Well Name: JOHN DENVER 15/14 FED COM	Well Location: T18S / R29E / SEC 15 / SWSW /	County or Parish/State: /
Well Number: 528H	Type of Well: OIL WELL	Allottee or Tribe Name:
Lease Number: NMNM0437524	Unit or CA Name:	Unit or CA Number:
US Well Number: 3001554413	Well Status: Drilling Well	Operator: MEWBOURNE OIL COMPANY

Sundry ID: 2762961

Type of Action: APD Change

Mewbourne Oil Company request that the following change be made to the John Denver 15/14 B2MP Fed Com #1H (APD ID # 10400084743):

Figure 9. Five valve 15k choke manifold.

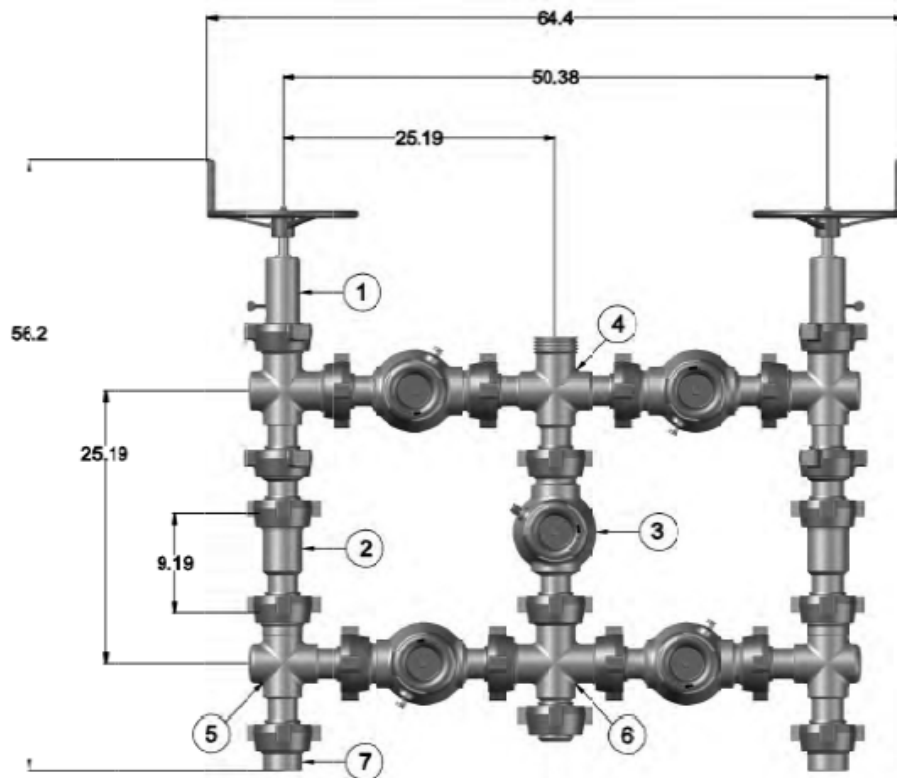
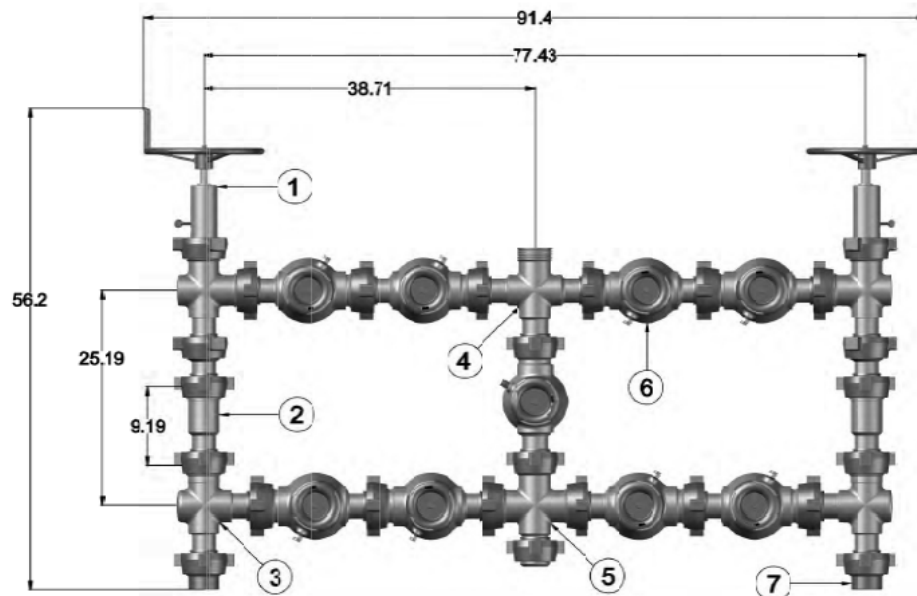
- Pressure build up in annulus before cementing
  - Contact BLM if a well control event occurs.
  - Rig up 3<sup>rd</sup> party pump or rig pumps to pump down casing and kill well.
  - Returns will be taken through the wellhead valves to a choke manifold (Fig 9 & 10).
  - Well could also be killed through the wellhead valves down the annulus.
